Office Action Summary	Application No. 10/586,110	Applicant(s) TILLMANN, HORST	
	Examiner ROBERTA DELISLE	Art Unit 3677

DETAILED ACTION

2. Claims 14-23 are rejected under 35 U.S.C. 102(b) as being anticipated by Ford (US 3,247,893).

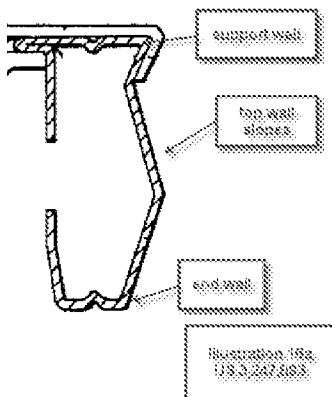
(New) The slide channel of claim 14, wherein the top wall is downwardly curved from the support wall toward the end wall **(See Illustration 15a below)**

(New) The slide channel of claim 14, wherein the top wall slopes from the support wall toward the end wall **(See Illustration 16a below)**

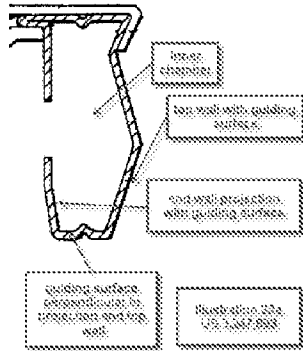
(New) The slide channel of claim 22, wherein the end wall comprises a second projection extending over the entire length of the housing and projecting into the inner chamber, the second projection having a surface which forms a fourth guiding surface of the plurality of guiding surfaces, wherein the top wall has a surface which forms a fifth guiding surface of the plurality of guiding surface, and wherein the end wall

further has a surface which forms a sixth guiding surface of the plurality of guiding surface, the fourth and fifth guiding surfaces facing each other and being perpendicular to the six guiding surface. **(See Illustration 23a below)**
